THE REGENT'S CANAL CONSERVATION AREA ADVISORY COMMITTEE 31 Oval Road, Camden Town, London NW1 7EA

King's Cross Central Fish and Coal Offices, Application Nos. 2014/5272/P and 2014/5273/P

We have objections to the enlargement of stables windows facing the towpath beneath Block 5 and to the remodelling of the roof of Block 4 as a conservatory. Also comments about the parapet of Block 2 and reusing historic bollards. Sorry for late response.

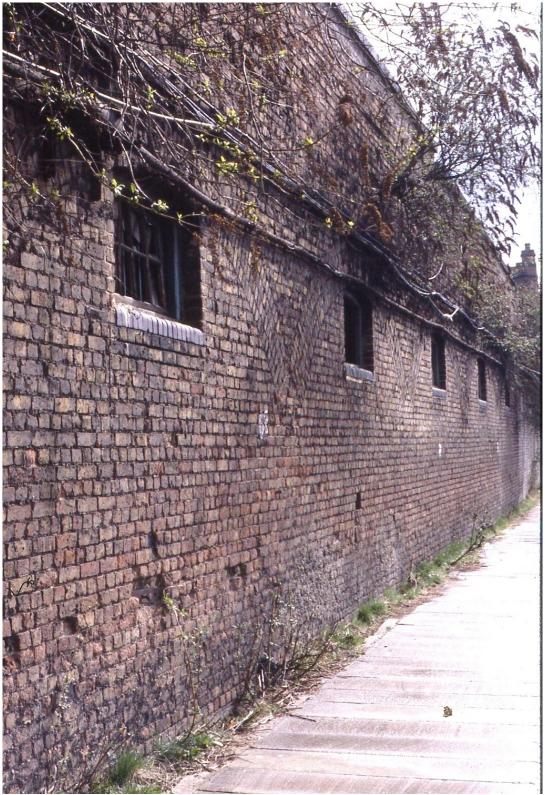
The proposals will considerably widen these windows (to 3 metres) and much lower their sills, so destroying their intrinsic character. Page 78 of the Urban Design Report under 'Response to Design Guidelines' is misleading, because it shows only the deepening of sills on the non-stables windows, which are already wide and relatively deep.

Characteristic stables windows under the Wharf Road Viaduct, seen before bricking up, similar to those under Block 5. These windows, inserted in the vaults when increasing railway traffic necessitated additional stabling capacity, symbolise the wide use of horses in 19th century railway operation.

Enlarging the stables windows would do much harm to the historic character, whereas the designers have taken care to protect historic character in most other aspects of the scheme. Not enlarging the stables windows would not jeopardise the putting of the building to new use So we ask you to request new proposals here as a condition of consent.

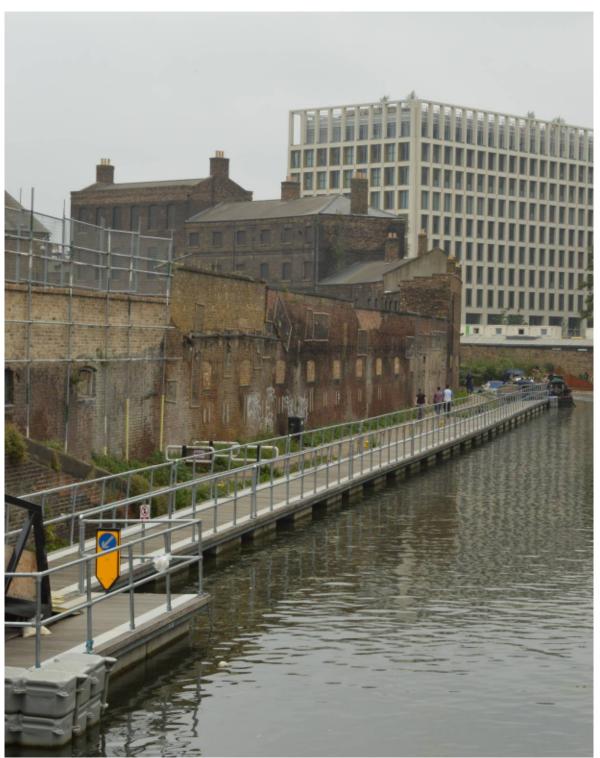
We object most strongly to the form of the glass conservatory at roof level in Block 4. This intervention severely disrupts the succession of slated pitched roofs and chimney stacks at descending levels which is the most striking and memorable feature of this remarkable range of buildings and a very positive contributor to the buildings' character. Its shape and materials rudely interrupt the building's architectural form and texture, which other efforts have striven to maintain. See photo at end of this letter. The conservatory is therefore very damaging to the character of the conservation area and should not be allowed. We would not oppose the raising of the roof of this block, to meet circulation and space requirements, if in a way somewhat similar to the rejected Option 4 in of the Urban Design Report (page 18), but raised further for useable headroom and with eaves aligning with the wall top there is still room to maintain a satisfying gradation of slated roofs. There is no demonstrated need for a glass roof. Page 19 refers to an 'overriding philosophy to make a clear distinction between old and new', but that is an invention of the designers and nothing absolute. Other more subtle ways could be used to indicate to the discerning eve that there has been an intervention (so avoiding the charge of pastiche), while not damaging the essential features of the roofscape.

View from St Pancras Lock, showing cascade of slate roofs on Blocks 2, 3 and 4. Replacing the Block 4 roof by a glass box will be highly damaging, and will also create confusion in the townscape between old buildings and new. Note that views from the intended footbridge will be similar to this, becoming a key view.
